SABIA, Inc.
7944 Convoy Court
San Diego, CA 92111
(858)279-4000
jmiller@sabiainc.com

September 27, 2004

United States Nuclear Regulatory Commission
Materials Safety Branch
Division of Industrial Safety and Material Nuclear Safety
Two White Flint North
11545 Rockville Pike
Rockville, MD 20852
Attention: Mr. Xiasong Yin

Reference: Your letter and Fax of September 7, 2004

Figure A
Model S-3 Source Housing

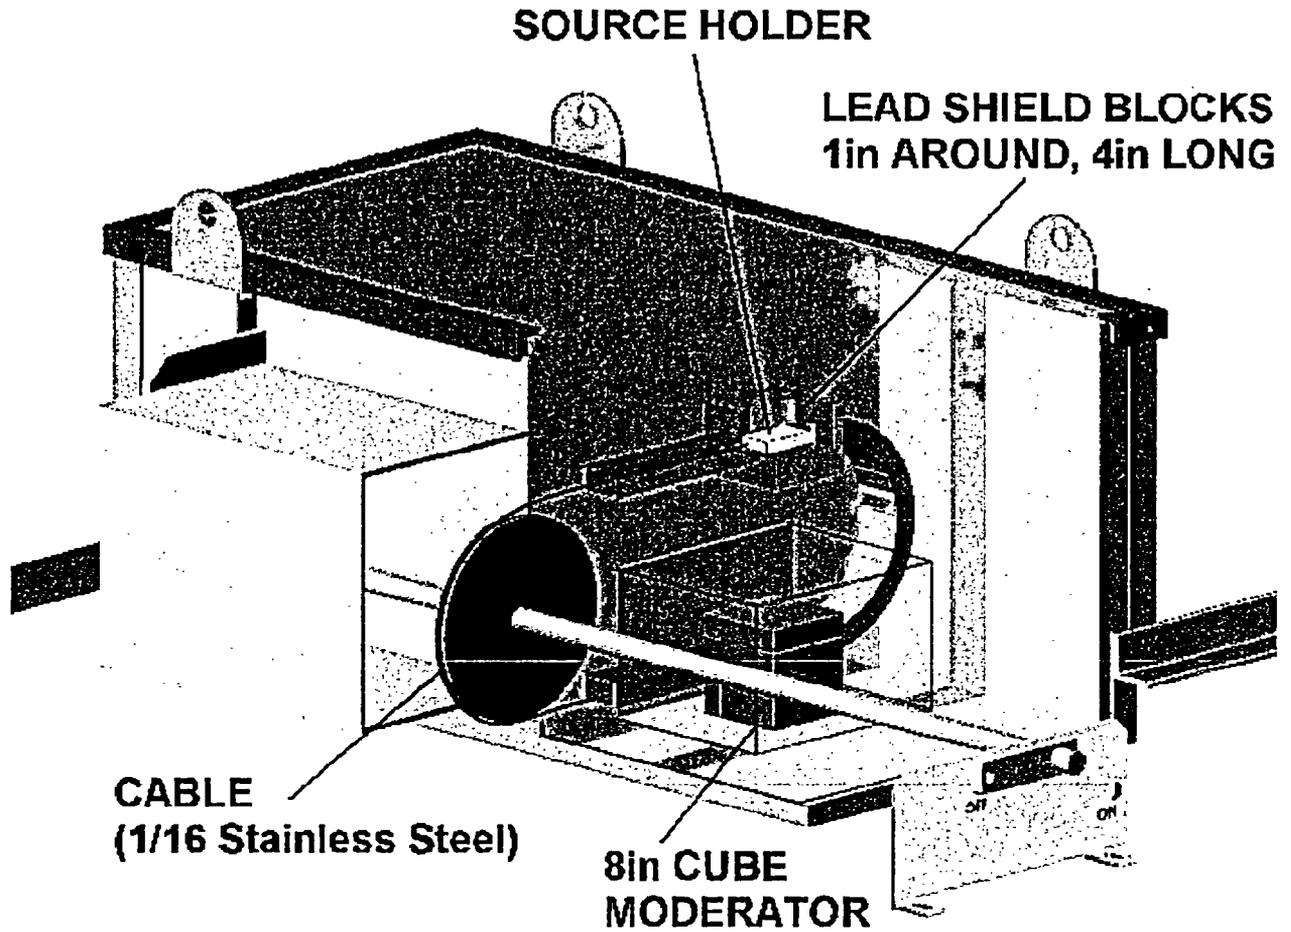
In reference to Figure A, provided with the SABIA letter of July 20, 2004. The source holder (Source Sled) is shown inside of the path assembly.

Figure A also shows the location of the 1-inch diameter shaft and drive wheel and stainless steel cable which provides the manual drive mechanism.

2.2 The device shutter is associated with the Model S-3 Source Housing, as shown in Figure A attached to the SABIA letter of July 20, 2004.

The source holder (Source Sled) is shown in the "OFF" position. This positions the sources centered within a 4 inch block of lead (which surrounds the path assembly). The 1-inch diameter shaft is supported by brackets attached to the side of the source housing. An arm is attached to the end of the shaft, which acts as a manual actuator for the source movement, and also provides the visual indication of source position (ON, OFF). A wheel attached to the shaft holds a stainless steel cable attached to the source holder (source sled). This stainless steel cable provides the mechanical movement for the source holder from ON to OFF positions. This is shown in Figure A. Mechanical stops on the source position indicator provides the mechanical limit for the ON and OFF positions. A hole through the arm aligns with a hole in the source position indicator when the sources are in the OFF position, allowing a lock to be inserted to prevent movement of the sources.

Figure B
Model XC- Series -25 Materials Analyzer

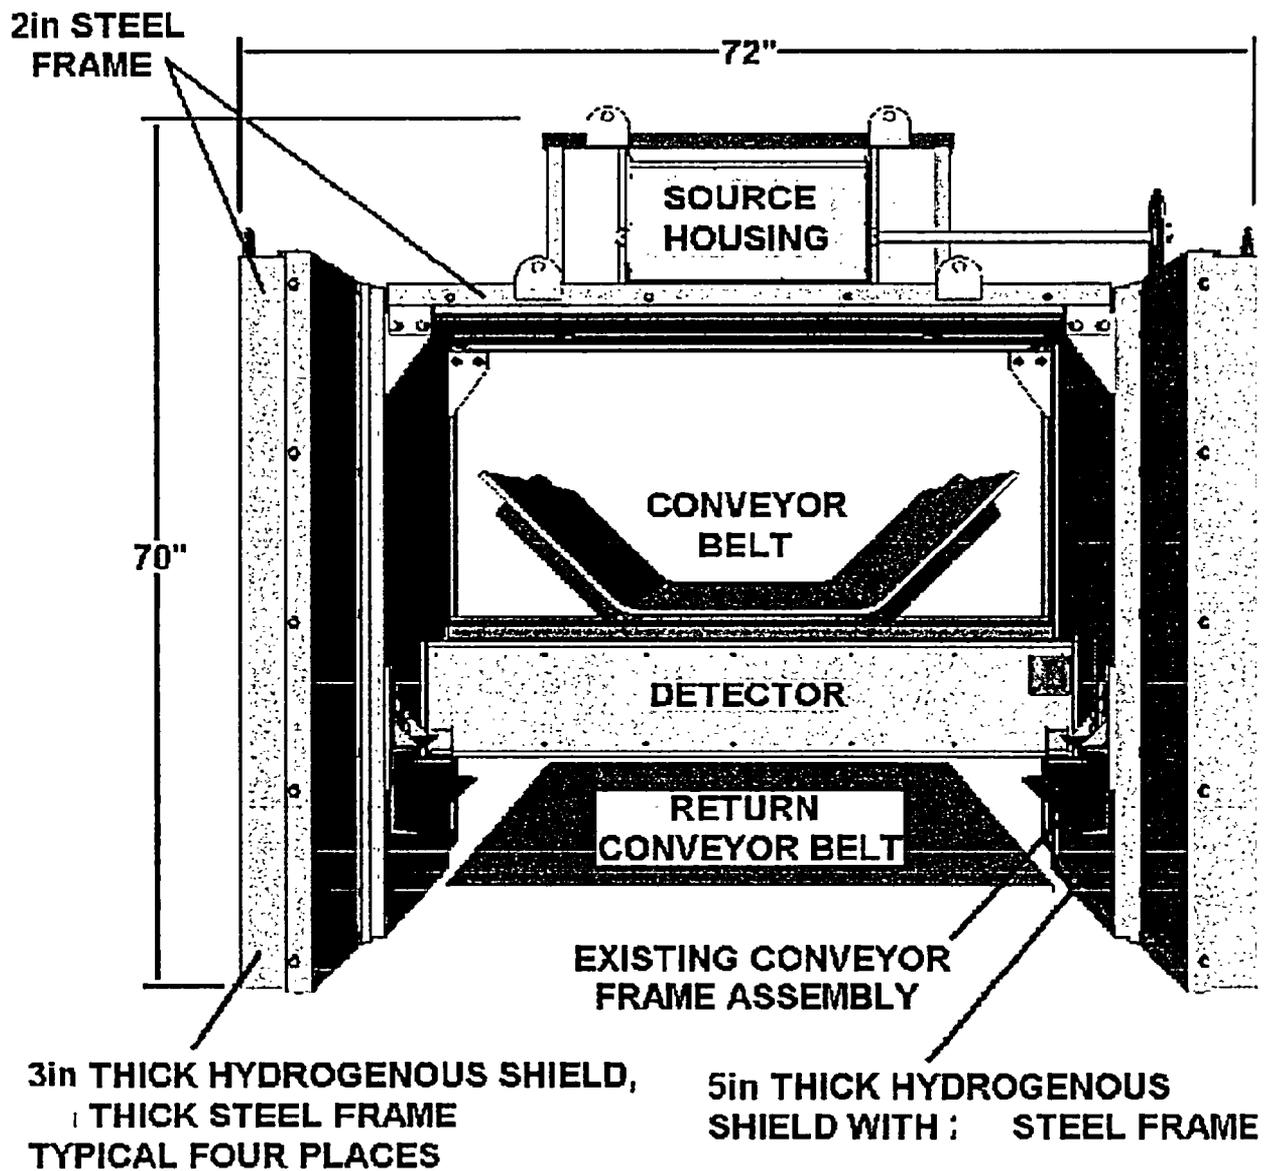
The primary shield is associated with the Model S-3 source housing. Figures B and C show the auxiliary shielding located within the 2 inch steel frame surrounding the conveyor belt. These two figures also show the location of the source housing and shielding in relative position to the conveyor belts.

Figure B shows the detector location in relative position to the conveyor belt and return conveyor belt.

Figure B shows the location of the detector in relation to the conveyor belt. Figure C shows the side view, which indicated the detector access cover in the side shield. This access cover is attached with 4 screws, and is designed to allow access to the detector for initial installation, or for repair or replacement by authorized personnel.

Figure C
Model XC – Series –25 Materials Analyzer

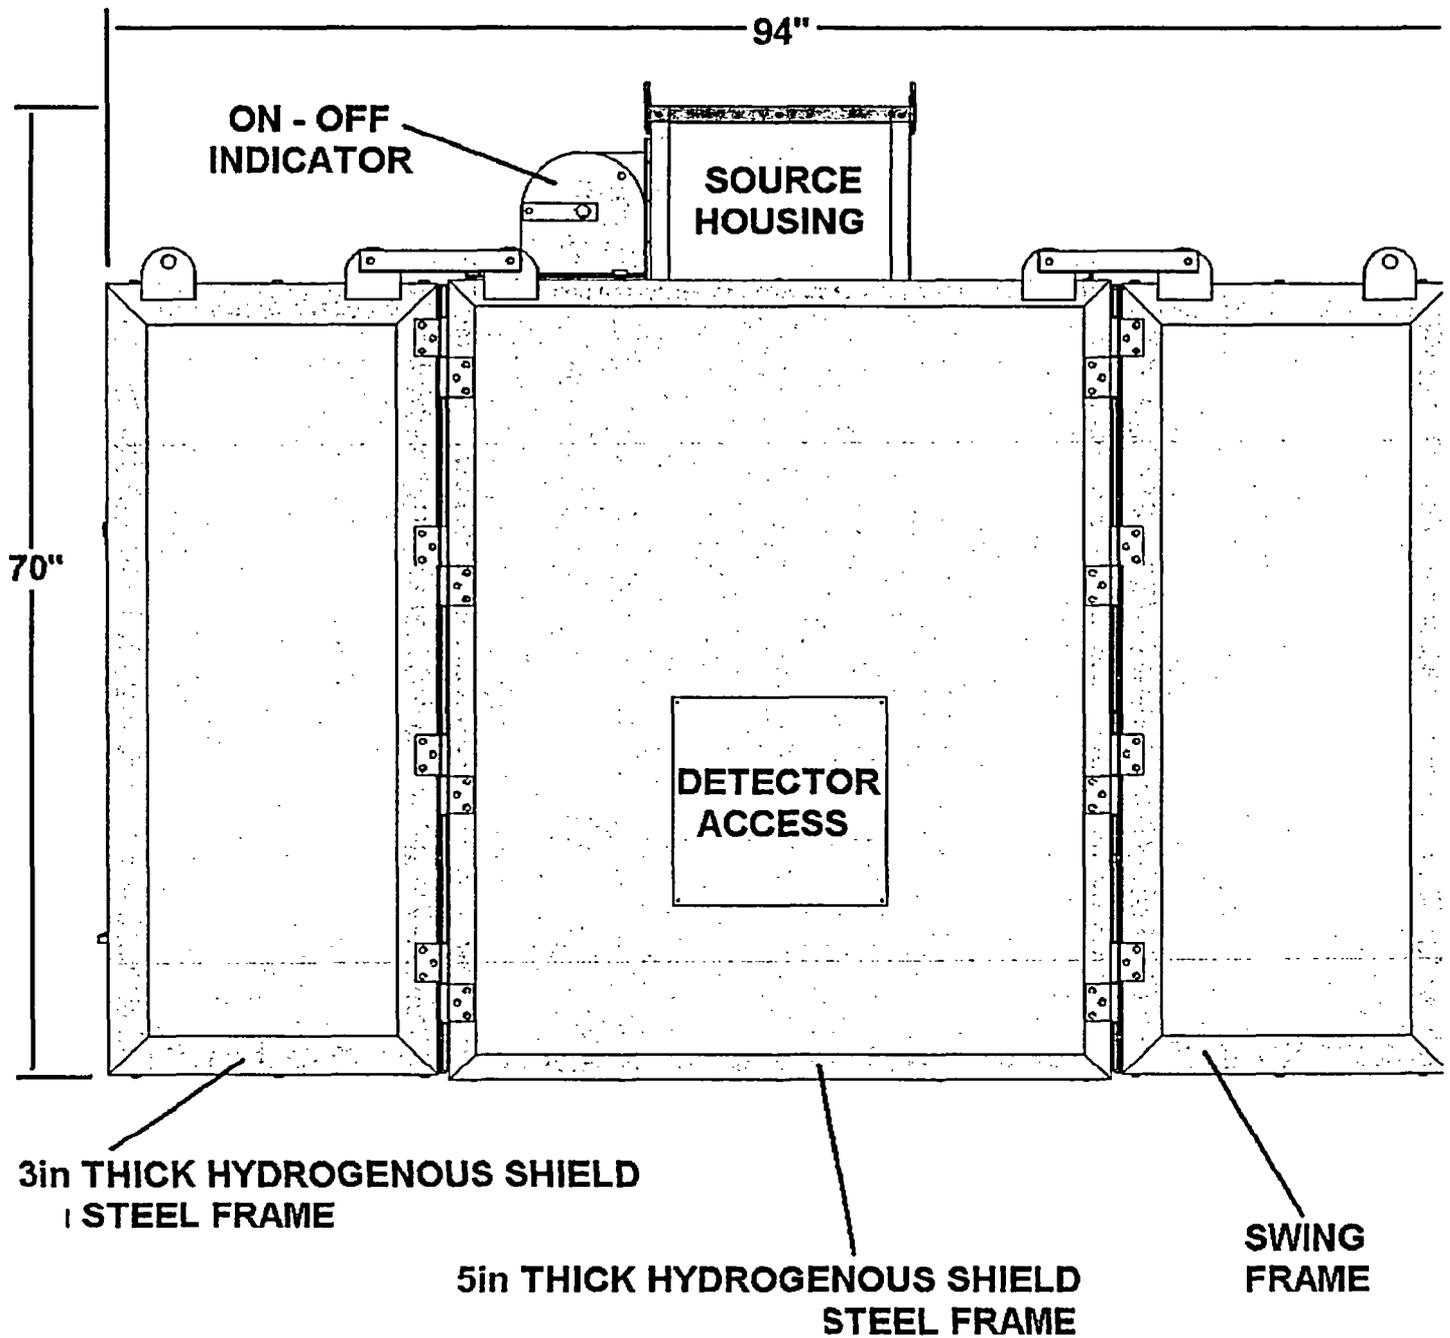
Figure C and Figure D show the swing frame(s). There are four, located two on each side of the shielding. These are bolted in the closed position, and allow access to the conveyor components for maintenance, when the sources are stored in the OFF position.

The source positioning plate, shown in Figure C, is a powder-coated steel plate marked with the source ON-OFF information in permanent white paint. On the maintenance intervals corresponding to source leak testing, SABIA, Inc. field personnel inspect all markings, and ensure that all indications are clearly legible. Touch-up of this marking is performed, if necessary, as a part of these semi-annual maintenance inspections.

Figure E
Source Housing for the
Model XC – Series Materials Analyzer

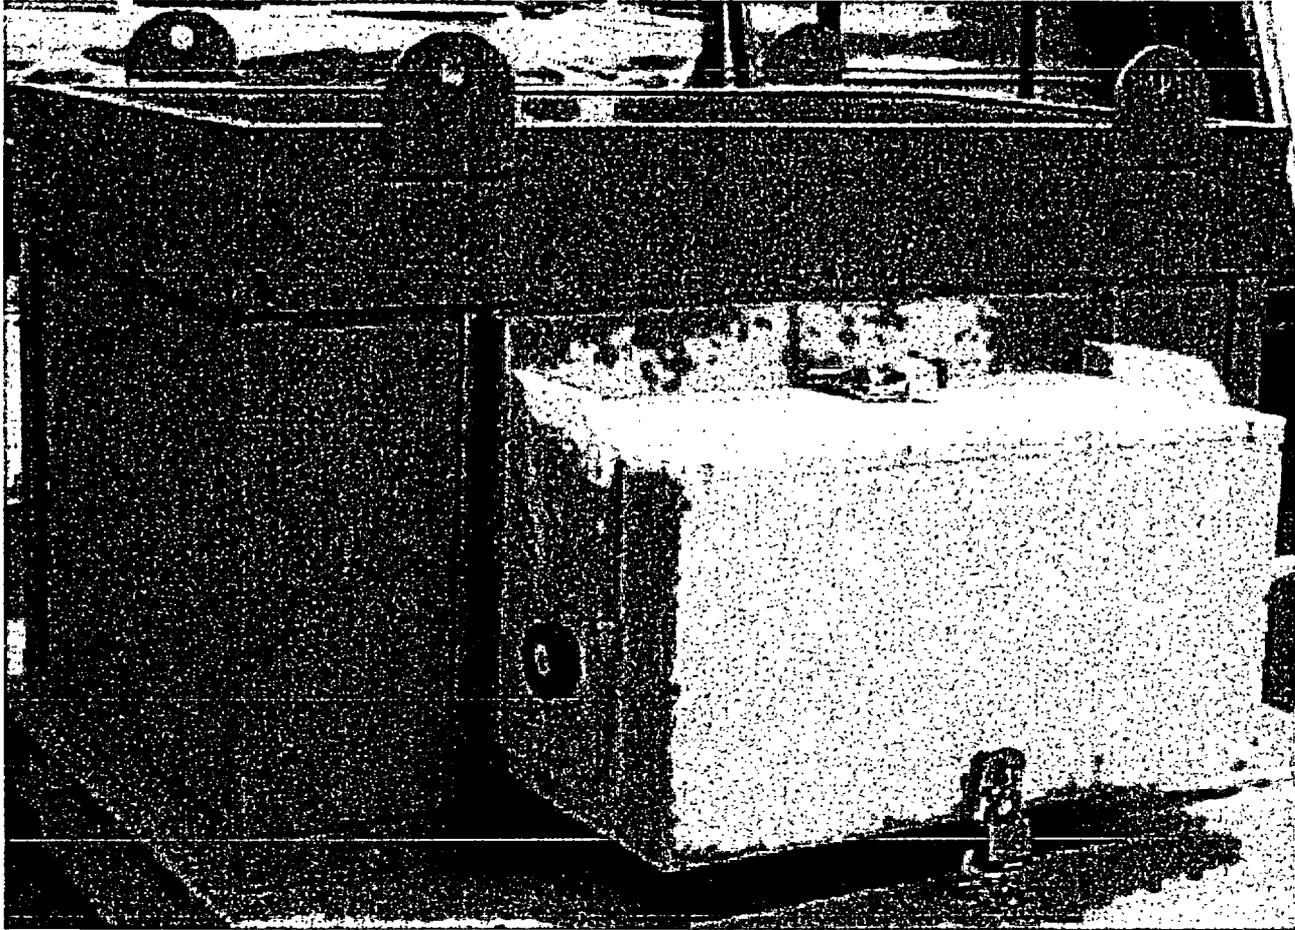
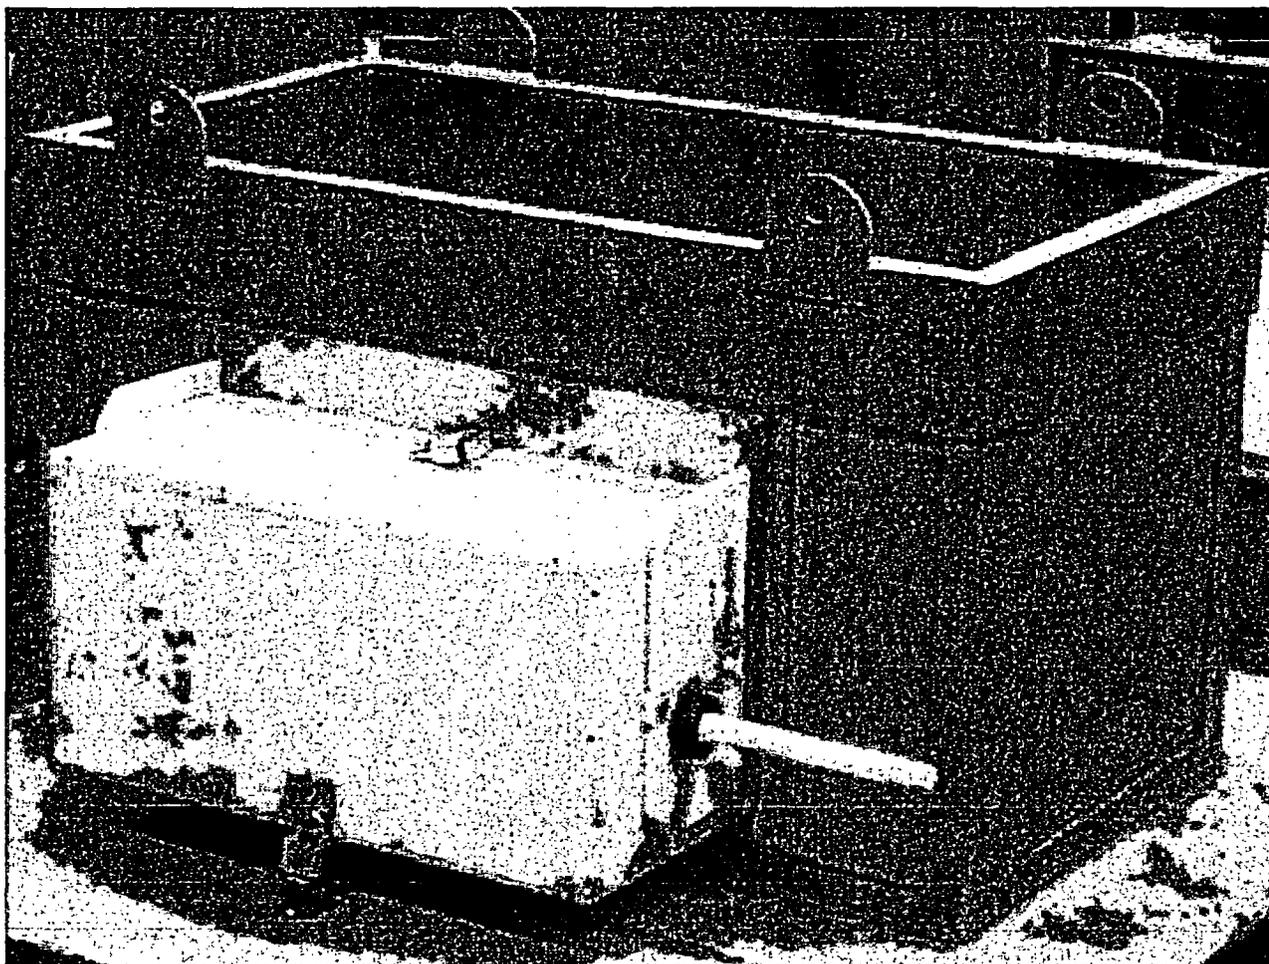
Attached are additional annotated photographs which indicate the location of the two hasps and locks on the source housing.
